Determination 2024/068

The issue of a notice to fix for a deck constructed without a building consent.

5/24 Eastglen Road, Glen Eden, Auckland

Figure 1. Building surveyor's annotated photo showing maximum height of deck

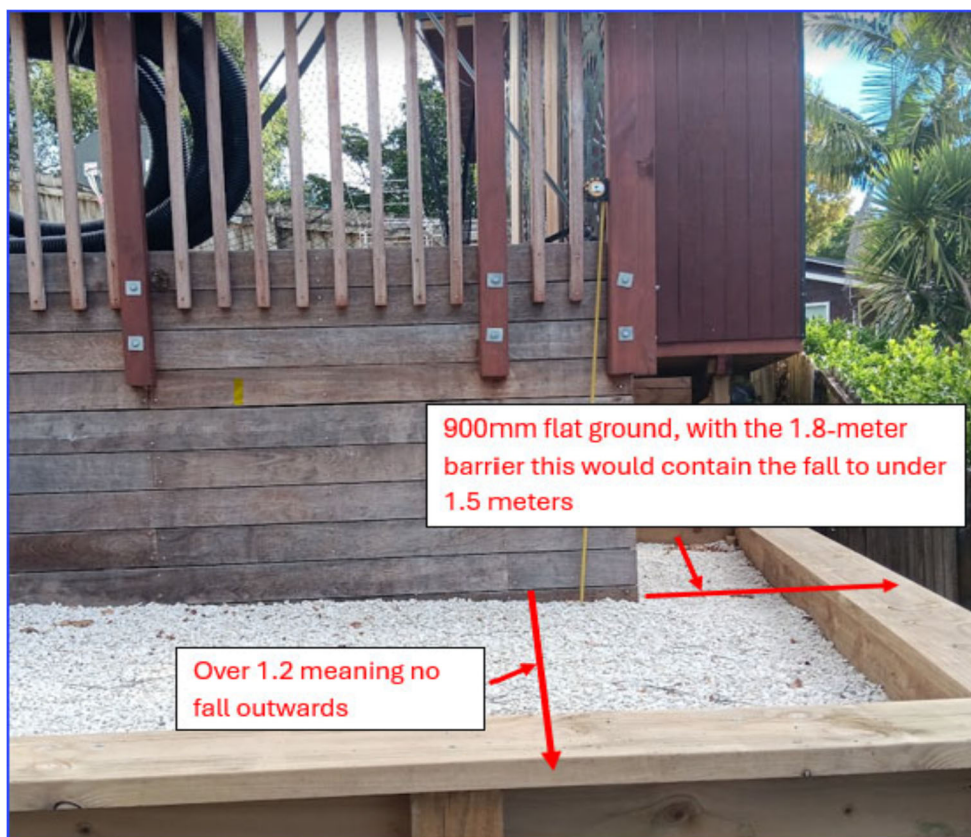
- 3.5. In response to the issue of the notices to fix, the owners engaged a building surveyor ("the building surveyor") to assist them in responding and taking steps of remediation works in their attempt to achieving compliance. The building surveyor provided a report on 21 February 2024. The report included an annotated photograph stating that at its highest point, in the northeastern corner, the deck was 1.7m above the ground level below, as shown in Figure 1.

- 5.12. In the first report dated 21 February 2024, the building surveyor acknowledged that the highest point of the deck (in its northeastern corner) was at 1.7m above the

ground level, indicating this on an annotated photo (see Figure 1). In the second report dated 2 April 2024, the building surveyor advised the height of the deck had been resolved by changing the surrounding ground level.

- 5.13. I have concluded that the height of the deck at its northeastern corner, and possibly at other points along that adjoining sides, is more than 1.5m above the level of the ground under the deck. This ground level would have been similar to that on the outside of the deck before the landscaping was done, which both parties' measurements have confirmed was over 1.5m.
